RE: LAKE COUNTY
MADISON TOWNSHIP
CLASSIC FORD
NPDES PERMIT NO. OHC000003
OHIO EPA PERMIT NO. 3GC05390*AG
CONSTRUCTION STORM WATER

On August 2, 2011, Ohio EPA conducted an inspection of the Classic Ford project located at 6251 N. Ridge Road, Madison Township, Lake County. Ohio EPA records indicate that the site is covered by the General National Pollutant Discharge Elimination System (NPDES) Permit for Storm Water Associated with Construction Activity (General Storm Water Permit), permit No. 3GC05390*AG. The inspection was conducted as a follow up to an inspection conducted on June 23, 2011, and documented the following:

Figure 1. The Inlet protection needs to be re-constructed and installed correctly.

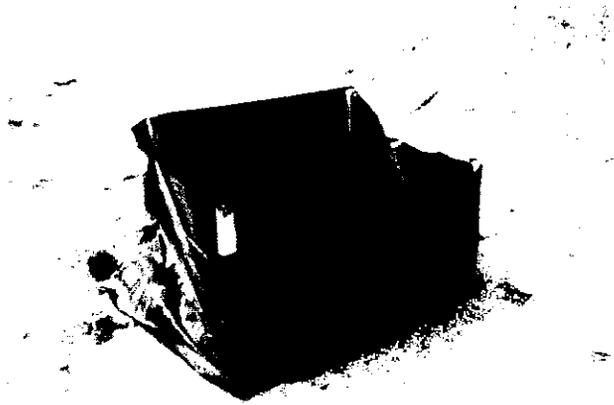
- **All issues documented during the previous inspection have been corrected.**
 - Please be sure to maintain all Best Management Practices (BMP's) for the remainder of the construction process.
- **The inlet protections are inadequate.**
 - After speaking with Rob Golinski on site, he informed me that Mr. Excavator is responsible for the installation and maintenance of inlet protections. Please be sure that geotextile frame inlet protections are constructed and installed properly; the geotextile needs to be reinforced with chicken wire, and the material needs to be trenched into the ground (the same way silt fence is trenched) in order to function properly (See Figure 1).
